24-DDP-0078

REZONING & SUBDIVISION
AKEN NORTH SUBDIVISION
 16907, 16907R, 16909 & 17140
 T.B. 16 LOTS: 8, 19, 61, 103
 D.B. W0424, P.C. 986 & 1000
 D.B. 9057 P.C. 818 & D.B. 1000

CASE #21-ZONE-0001
 MSD WM #12220

24-DDP-0078

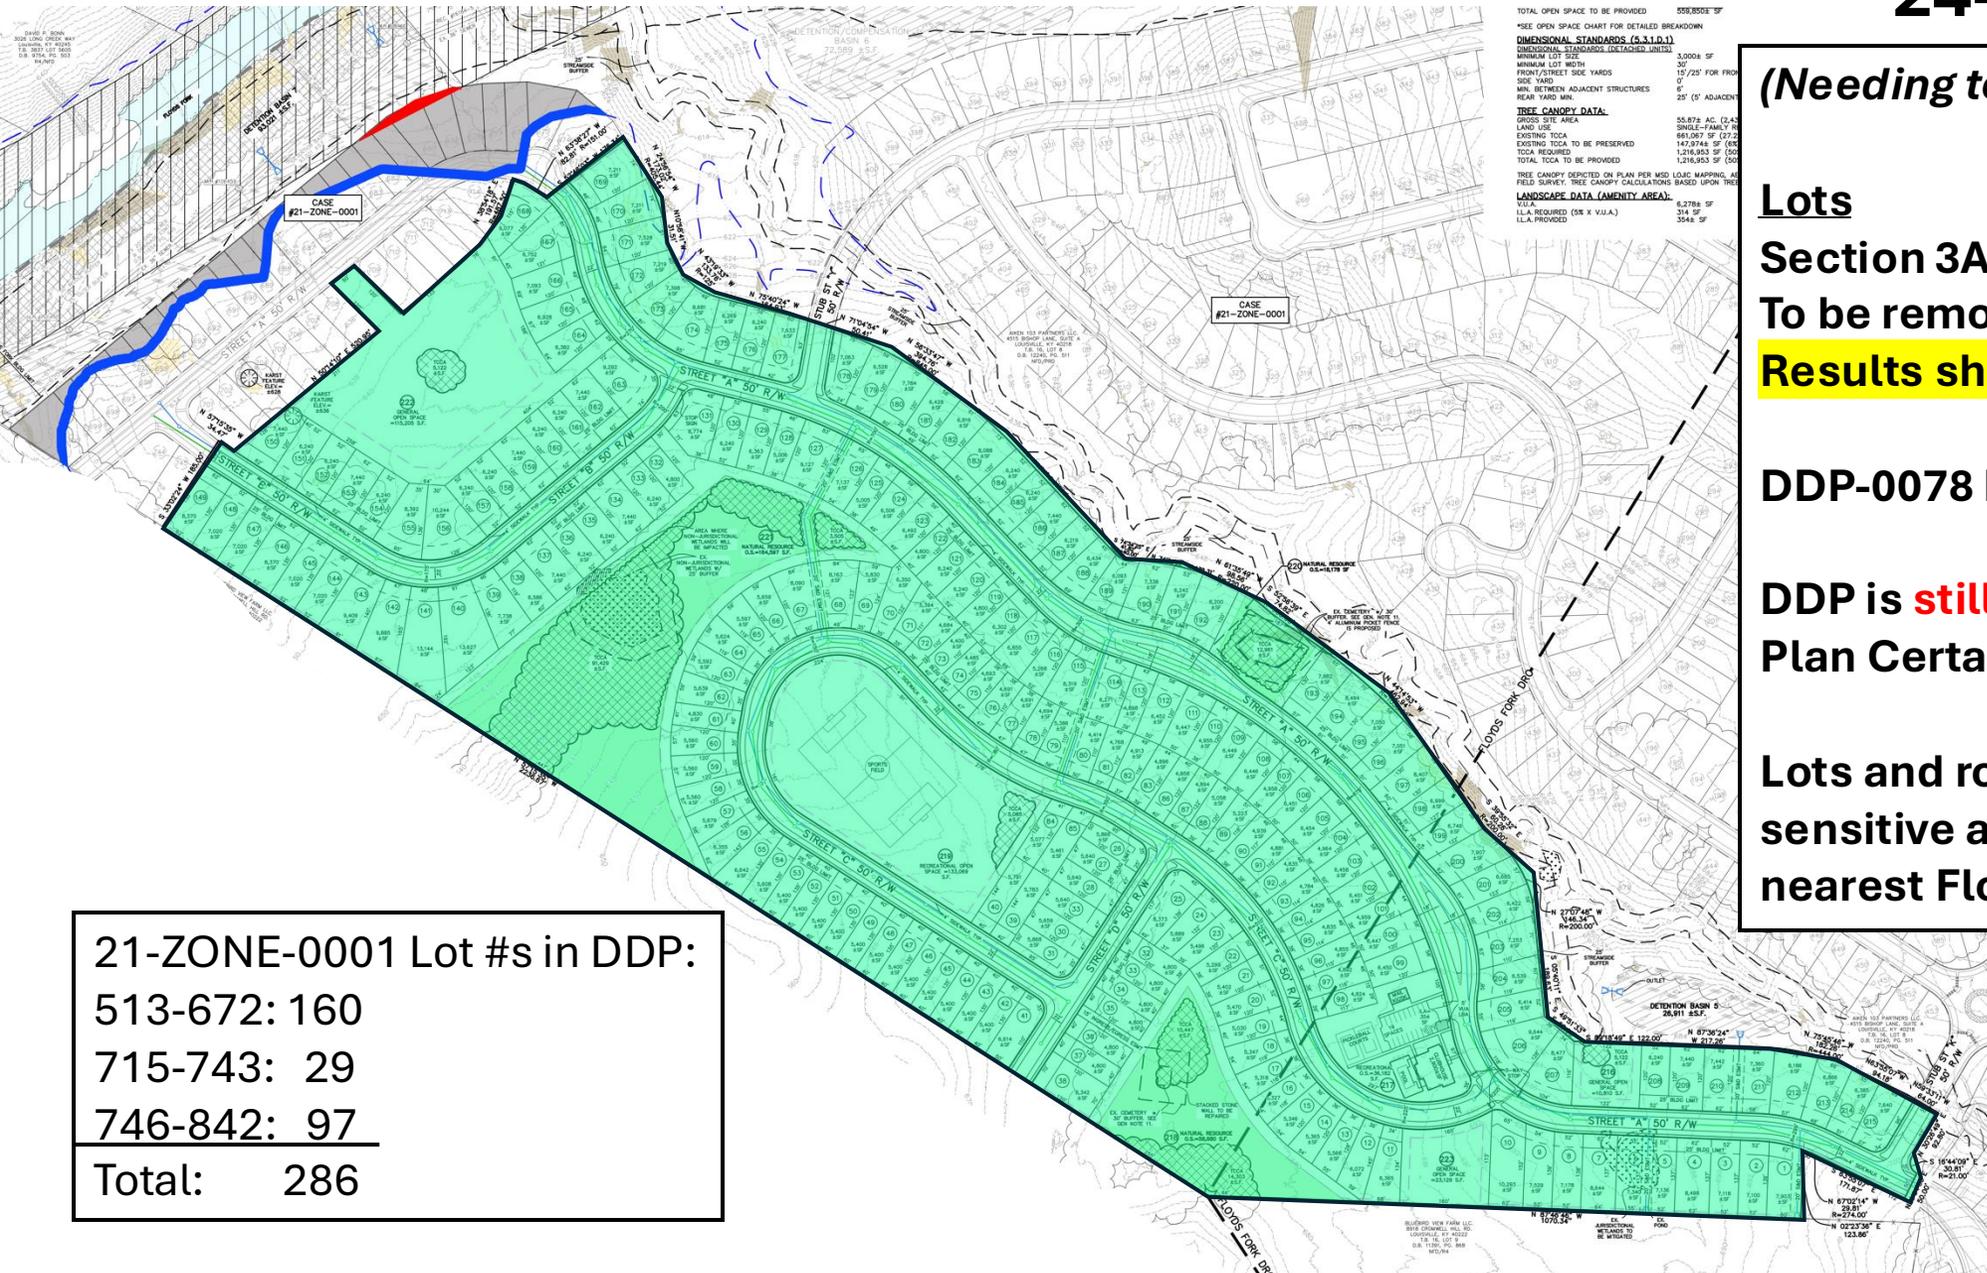
(Needing to remove 92 lots)

Lots	
Section 3A originally	286
To be removed	- 92
Results should be	194

DDP-0078 Request: 215

DDP is **still 21 lots over** the 866 Plan Certain

Lots and roadway still in most sensitive areas of "Section 3" nearest Floyds Fork

21-ZONE-0001 Lot #s in DDP:
513-672: 160
715-743: 29
746-842: 97
Total: 286
